# Access Compliance Report

## Public Rights-of-Way (Curb Ramps)

Intersection ID: 3757	Main Street: DAVIS_LAKE_PY	Cross Street: POPLAR_GROVE_DR	Location: SW
ADA ID: 76F091BE5E68	Ramp Type: Perp	Initial Pass/Fail: Fail	Overall Compliance: No
		Severity Score: 8.75

### Codes/Mitigation Info/Possible Solution

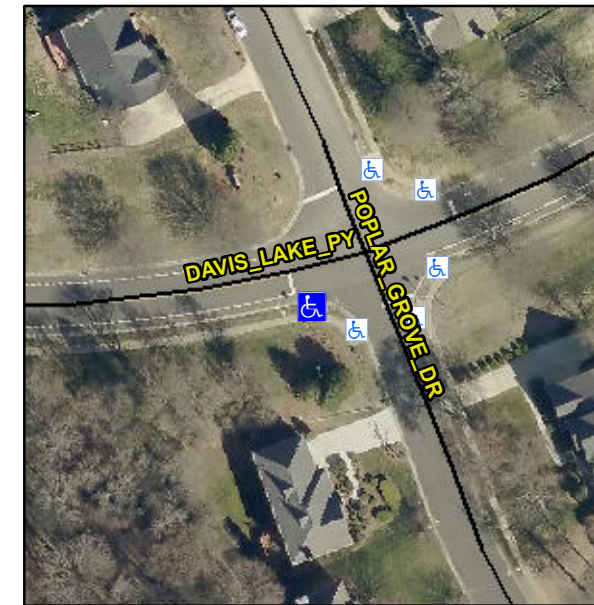
**Not Found, R304.5.1**

Compliance	Description	Data	Compliance	Description	Data
N/A	Ramp Length (in)	54.0	Yes	Ramp Slope (%)	5.7
No	Ramp Width (in)	47.0	Yes	Ramp XSlope (%)	0.9
N/A	Flare Type LT	N/A	N/A	Flare Type RT	N/A
N/A	Flare Slope LT (%)	N/A	N/A	Flare Slope RT (%)	N/A
N/A	Flare Traversable LT?	N/A	N/A	Flare Traversable RT?	N/A
N/A	Landing Length (in)	N/A	N/A	DWS Provided?	N/A
N/A	Landing Width (in)	N/A	N/A	DWS Contrast?	N/A
N/A	Landing Slope (%)	N/A	N/A	DWS Length (in)	N/A
N/A	Landing X Slope (%)	N/A	N/A	DWS Full Width?	N/A
N/A	Landing Curb? (Y/N)	N/A	N/A	DWS Offset (in)	N/A
N/A	Shared Landing?	N/A			
N/A	Gutter Ponding?	N/A	N/A	Gutter Slope (%)	N/A
N/A	Gutter Lip Ht (in)	N/A	N/A	Gutter X Slope (%)	N/A
N/A	Painted X Walk1?	No	N/A	Painted X Walk2?	N/A
	X Walk 1 Direction	To N		X Walk 2 Direction	N/A
N/A	X Walk 1 Width (in)	N/A	N/A	X Walk 2 Width (in)	N/A
	X Walk 1 Slope (%)	7.3		X Walk 2 Slope (%)	N/A
	X Walk 1 X Slope (%)	2.0		X Walk 2 X Slope (%)	N/A

**Remove & Replace Entire Ramp.**
